SERVICE INSTRUCTIONS

No. 0042-031, Rev. II
ATA Code 53-40
Recurring Inspection

SUBJECT: FUSELAGE - INSPECTION OF FORWARD WING ATTACH POINT

Figure 1.

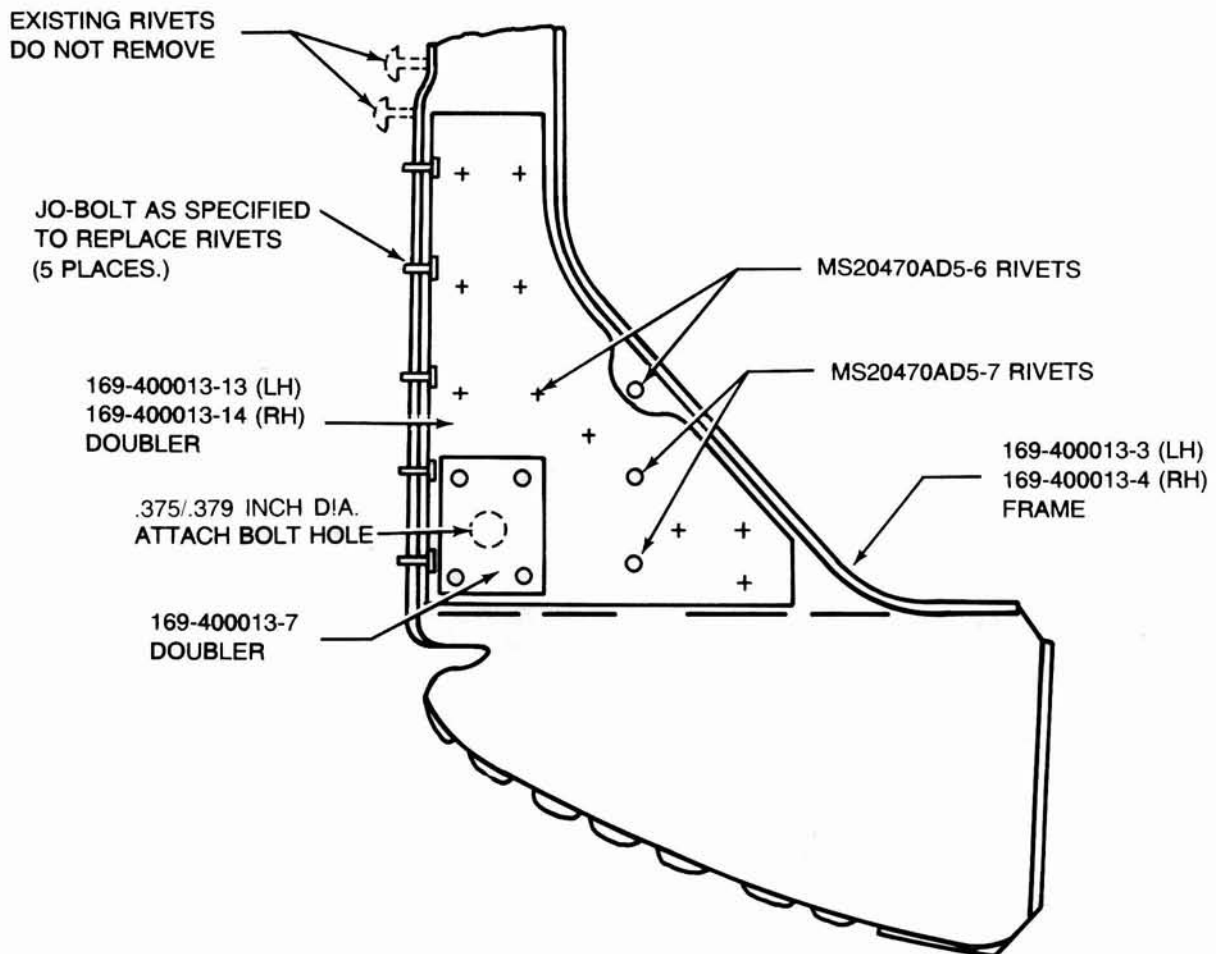
- a. Remove the pilot and copilot seats, forward carpets and upholstery panels below the cabin doors.
- b. At each 100 hour, annual or periodic inspection, visually inspect for radial or circumferential cracks around the wing attach bolt head or nut in the following parts: P/N 169-400013-3 (LH) frame, P/N 169-400013-4 (RH) frame, P/N 169-400013-5 (LH) bracket, P/N 169-400013-6 (RH) bracket and the following doublers, if installed: P/N 169-400013-7 (LH and RH), P/N 169-400013-13 (LH), P/N 169-400013-14 (RH), 169-400013-45 (LH) and P/N 169-400013-46 (RH).

Each 500 hours after the accumulation of 2000 hours in service (i.e. at 2000, 2500, 3000 hrs, etc.), this inspection is to be accomplished by loosening the nut on the attach bolt and inspecting for possible cracks in the above parts using dye penetrant procedures as outlined in AC43.13-1A.

3. Drill out the three rivets through the bracket and frame, and the five rivets through the outboard flange of the bracket and the fuselage skin (See Figures 1 and 2), and discard the bracket.

Figure 2.

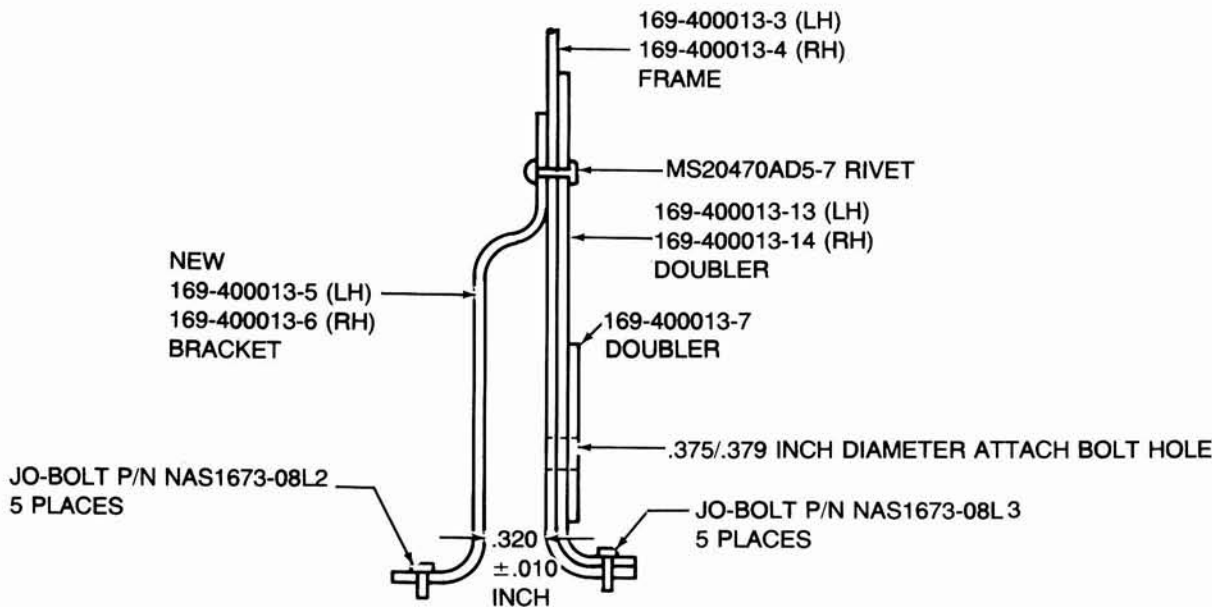
169-400013-1 (LH), 169-100013-2 (RH) FRAME ASSEMBLY

Figure 3.

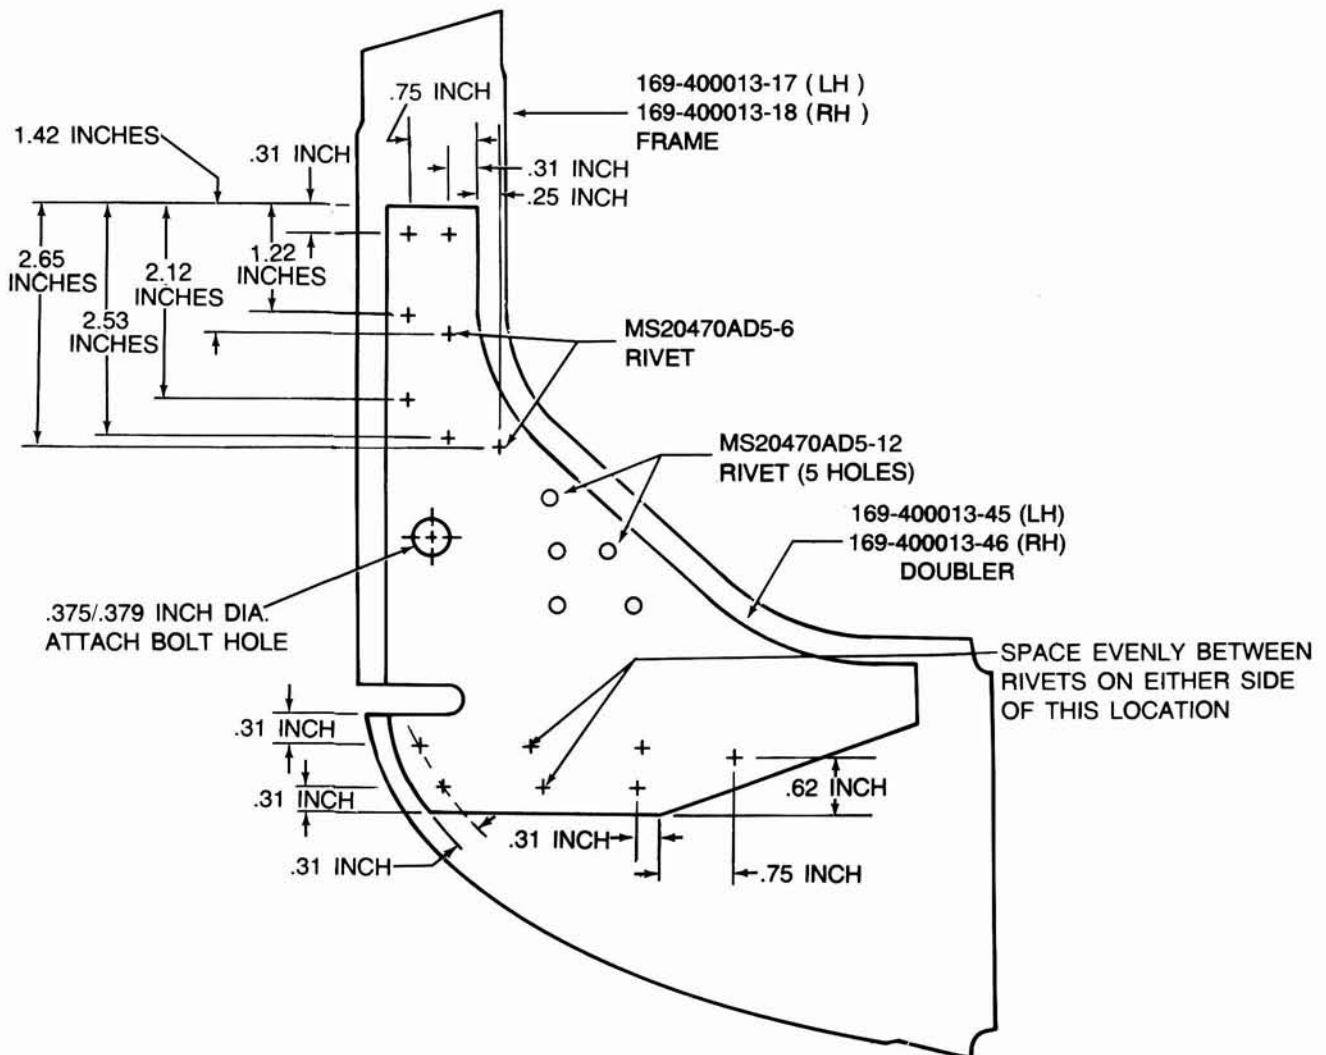
- b. Remove the nut on the wing attach bolt and measure the gap between the wing attach frame and the bracket to ensure the gap is $.320 \pm .010$ inch. Do not remove the attach bolt.

- d. If the gap exceeds $.320 \pm .010$ inch, back the wing attach bolt out just far enough to install P/N AN960-616 and/or AN960-616L washers as required to fill any gap between the lug on the wing and the bracket or frame. If a P/N AN960-616 washer is not installed under the head of the bolt, the bolt must be removed.

- e. Ensure a P/N AN960-616 washer is installed under the head of the wing attach bolt and install the bolt. Install a P/N 100951DD063YN washer on the bolt next to the bracket, then a P/N AN960-616 washer, and install an MS20365-624A nut. Torque the nut to 100/120 inch-pounds and reinstall the side panels, carpets and seats.

Figure 4.

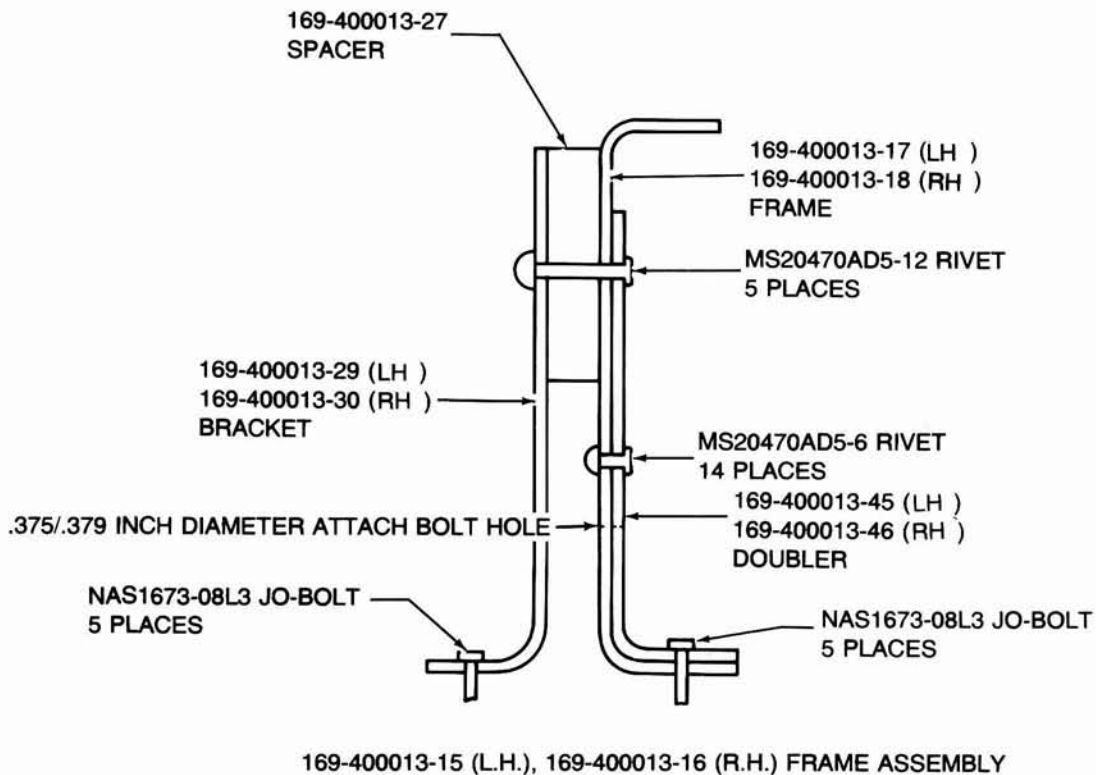
5. Position a P/N 169-400013-45 (LH) or P/N 169-400013-46 (RH) doubler on the frame
